Access Compliance Report

Public Rights-of-Way

(Curb Ramps)

Intersection ID: 10033675	Main Street: ORCHARD_LAKE_DR	Cross Street: N/A	Location: NE
ADA ID: FB04C2ECA282	Ramp Type: Perp	Initial Pass/Fail: Pass	Overall Compliance: No
		Severity Score: 17.5

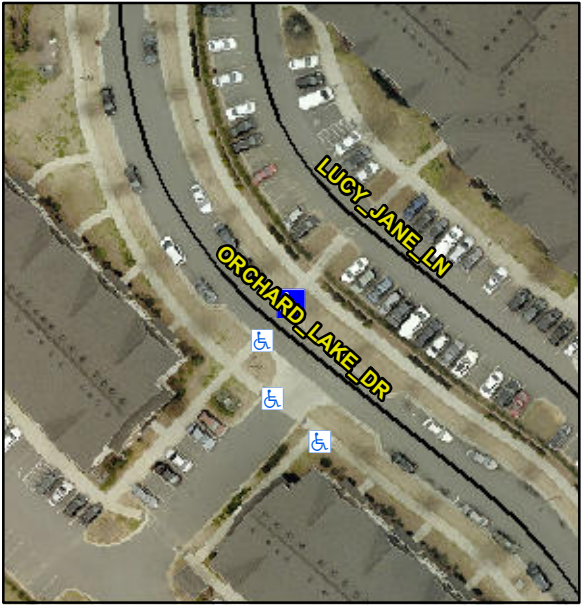
Codes/Mitigation Info/Possible Solution			Field Measurements/Component Compliance		
	Possible Solutions:		Compliance	Description	Data
	Remove & Replace Entire Ramp.		Yes	Ramp Length (in)	169.0
			Yes	Ramp Width (in)	71.5
			N/A	Flare Type LT	Sloped
			N/A	Flare Slope LT (%)	0.1
			N/A	Flare Traversable LT?	No
			Yes	Landing Length (in)	71.0
			Yes	Landing Width (in)	72.0
			Yes	Landing Slope (%)	0.1
			Yes	Landing X Slope (%)	0.9
<p>Surveyor Notes:</p> <p>N/A</p> <p>PROW/ADA:</p> <p>Not Found, R305.1.4, R302.7.2</p>			N/A	Flare Type RT	N/A
			N/A	Flare Slope RT (%)	6.9
			N/A	Flare Traversable RT?	No
			Yes	DWS Provided?	Yes
			Yes	DWS Contrast?	Yes
			Yes	DWS Length (in)	24.0
			No	DWS Full Width?	No
			Yes	DWS Offset (in)	1.0
			No	Gutter Ponding?	No
			No	Gutter Lip Ht (in)	1.0
			N/A	Painted X Walk1?	No
				X Walk 1 Direction	To SW
			N/A	X Walk 1 Width (in)	N/A
				X Walk 1 Slope (%)	1.2
				X Walk 1 X Slope (%)	0.3

N/A	Ramp inside XWalk1?	N/A
			N/A	Road Slope (%)	N/A
			N/A	Road X Slope (%)	N/A
			Yes	Any Obstructions?	No
				Obstruction Type	
Total Cost: \$ 1850.00			N/A	Storm Grate/Utility Hazard?	No
				Storm Grate/Utility Type	
			N/A		N/A
			Yes	Surface Condition? (G/P)	Good
